Planning Commission

Meeting Minutes

Planning Commission Staff Report January 18, 2017 Meeting

TURKEY HILL FRESH EATS SIGN VARIANCES

Staff’s recommendation for the Fresh Eats signs:

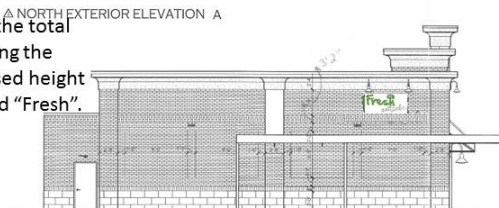
Staff does not recommend approval of the requested variances based on the current signs’ design. The car wash has signage that is taller and larger than code requirements. Previous variances for the car wash signs were approved by the Planning Commission based on the fact that there is only one wall sign on the convenience store and no signage on the gas pump canopy. Planning Commission and staff felt the site would not appear “over signed” with larger and taller signage at the car wash. Adding an additional 82 square feet of signage between the two Fresh Eats signs may “tip the scales” of over signing the site. Additionally, the signs are not an appropriate size based on the size and scale of the building and the existing Turkey Hill wall signage. The Fresh Eats signs are larger in area and height than the existing Turkey Hill sign and cover architectural detailing on the building’s exterior. Finally, the font, size and colors are not integrated with the existing wall sign on the conveniences store building.

While staff does not support the request, we offer a recommendation below should the Planning Commission wish to consider approval of the application. Staff recommends that both signs are scaled down in size so they fit below the proposed lighting and above the soldier course. This results in the total sign height being the original proposed height of just the word “Fresh.” If both of the entire signs are proportionally scaled down so the total sign height is reduced from 52 inches to 30 inches the signs would not cover any architectural detailing or create an appearance of competition between the existing Turkey Hill sign. This results in the sign becoming closer to the appropriate in scale, design, and intensity of the existing signage. Staff believes this will also reduce the appearance of over signing the site.

Scaled down so it above the soldier course and below the proposed lighting.
Total sign height reduced from 52 inches to 30+/- inches.

This results in the total sign height being the original proposed height of just the word "Fresh".

1. A second wall sign for Fresh Eats is permitted on the front elevation.
2. Both Fresh Eats signs are scaled down so they are located below the proposed lighting and above the soldier course. Both of the entire signs are proportionally scaled down so the total sign height is reduced from 52 inches to 30 inches.
